**Subject** ▶ Change on blade case and rubber ring

**For Models** ▶ 5903R and 5903

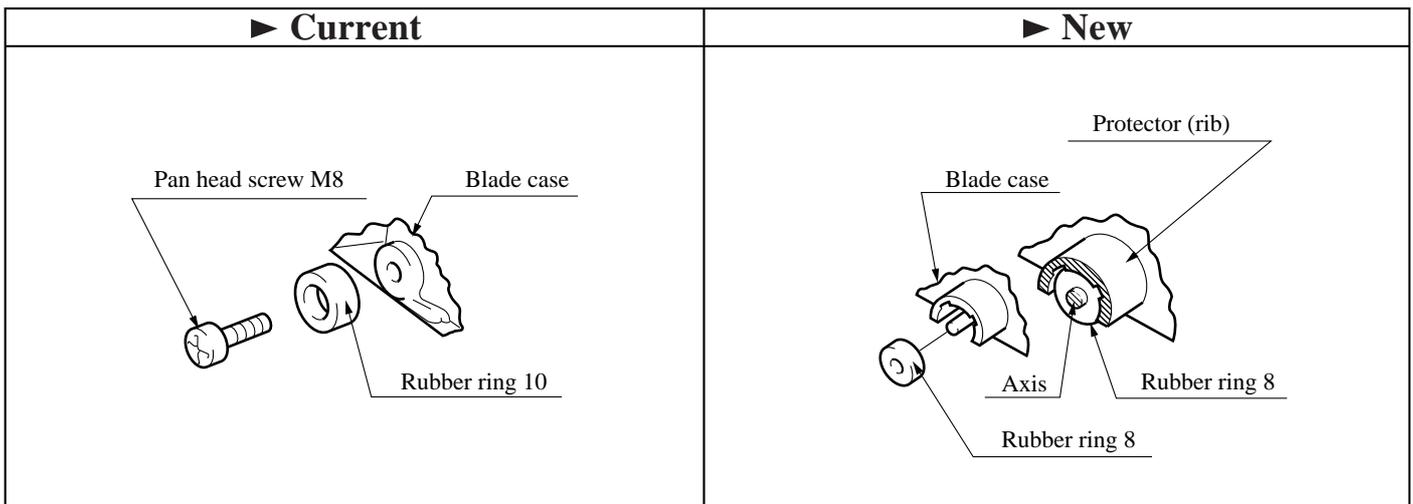
**Description** ▶ 1. Two holes will be made in the blade case. As shown in the figure below, the strain relief securing screws can be loosened by inserting a screwdriver through the holes in the blade case. It is not necessary to remove the blade case from the motor housing when removing the strain relief.
